## Certified Action of the City of Raleigh Planning Commission

**Case File / Name:** SP-26-12 / Waffle House Dixie Forest

**Nature of Case:** The construction of an 1,875 square foot eating establishment with no drive-thru on a 0.72 acre parcel zoned Shopping Center CUD.

SP-26-12 / Waffle House Dixie Forest – Site Plan

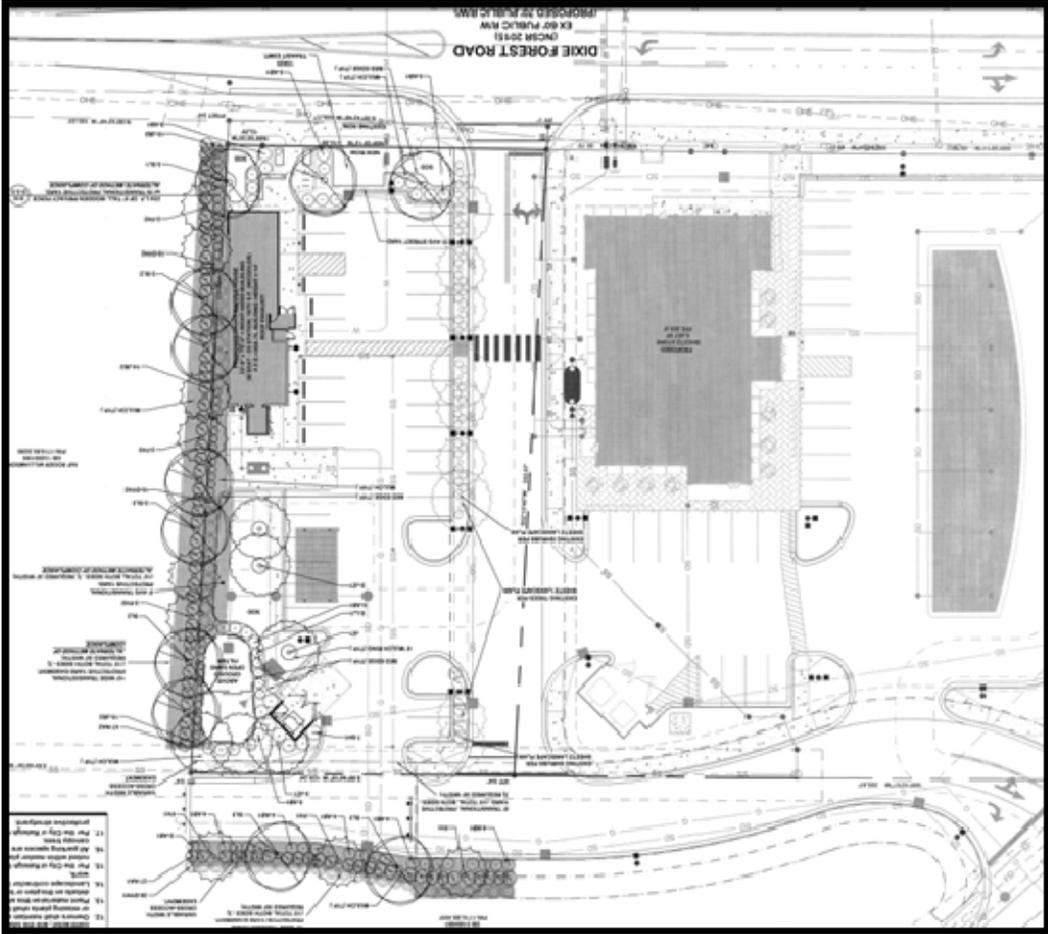
**Key Issues:** Code Section 10-2082.4 an alternate means of compliance is being requested from providing a 30' type B transitional protective yard along the western property line. The alternate is a closed wooden fence and a 15' transitional protective yard along the western property line. 1 tree will be planted every 20 linear feet with evergreen shrubs planted 5' on center.

**VARIANCES /  
ALTERNATES:** The proposal includes a requested alternate means of compliance from providing a 30' type B transitional protective yard along the western property line.

| <u>Comment</u>  | <u>Response</u>  |
|---|--|
| That the L-shaped seat wall adjacent to the patio area be masonry-clad to visually connect it with the base band of the building                    | The seat wall will be masonry-clad to match the base of the building |
| Moving the westernmost tree adjacent to the patio area further west to enlarge the patio area.  | Tree was shifted to the western property line                        |
| That the applicant consider adding gooseneck lighting, and using different materials in lieu of shutters such as recessed panels with brick detail. | Prefer to keep the shutters and rear elevation as proposed           |
| Consider provision of shelter at bus bench locations.   | Transit Division did not request a shelter                           |

The alternate is a 6' closed wooden fence with a 15' transitional protective yard is provided on the western property line. 1 tree will be planted every 20 linear feet with evergreen shrubs planted 5' on center. Trees will be installed at 2.5" caliper (code requirement 2") and a height of 10' (code requirement 8'). Evergreen shrubs will be installed at a height of 24" (code requirement 18").
